**Before the Louisiana Public Service Commission**

Docket No. U-32507

**Direct Testimony of  
Jeremy I. Fisher, PhD**

**On Behalf of  
Sierra Club**

12 **Figure 1. Net present value of retrofit benefit at RPS2 in Cleco analysis (top bar)**  
 13 **and with adjustments for capacity balance, carbon pricing, and environmental**  
 14 **regulations. Synapse base case in orange.**

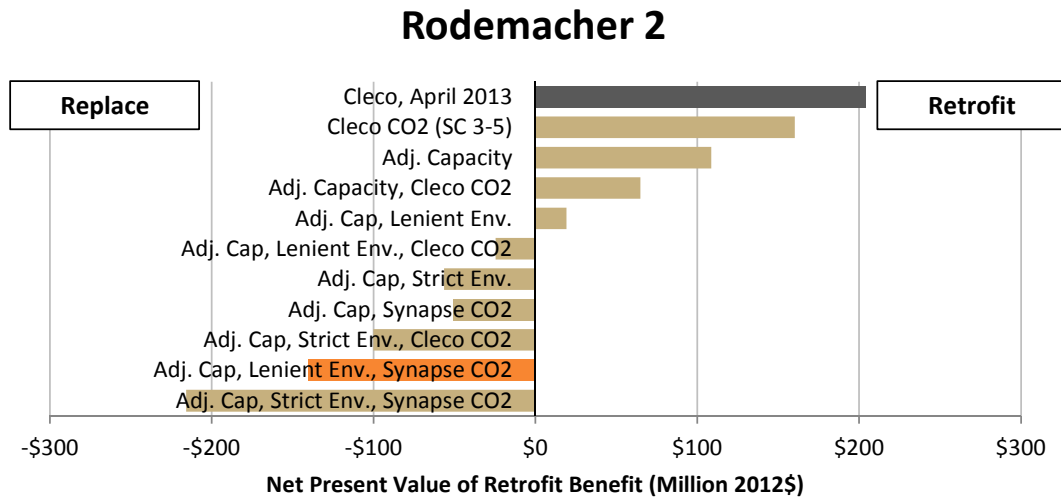
18 **A** Using a baseline gas price forecast from the Energy Information Administration's  
19 (AEO) 2013 Annual Energy Outlook (EIA), I found that in a reasonable baseline  
20 scenario, both RPS2 and DHPS are anywhere from marginal to vastly non-  
21 economic. Only in the circumstance that there is no imposed carbon price and that  
22 the EPA scraps all stated plans for future regulation of air and water quality and  
23 toxic wastes, does it make any sense to retrofit these coal units. The moderate  
24 economic advantage found by the Company is completely eroded by corrections  
25 and the contemplation of reasonable risk.

26 The graphics below indicate the net benefit of retrofitting the Company's units in  
27 the Cleco 2013 analysis (Mr. Sharp's supplemental testimony), and with various  
28 corrections to adjust for the Company's oversized replacement capacity, various  
29 levels of carbon price risk, and other environmental regulations at both a lenient
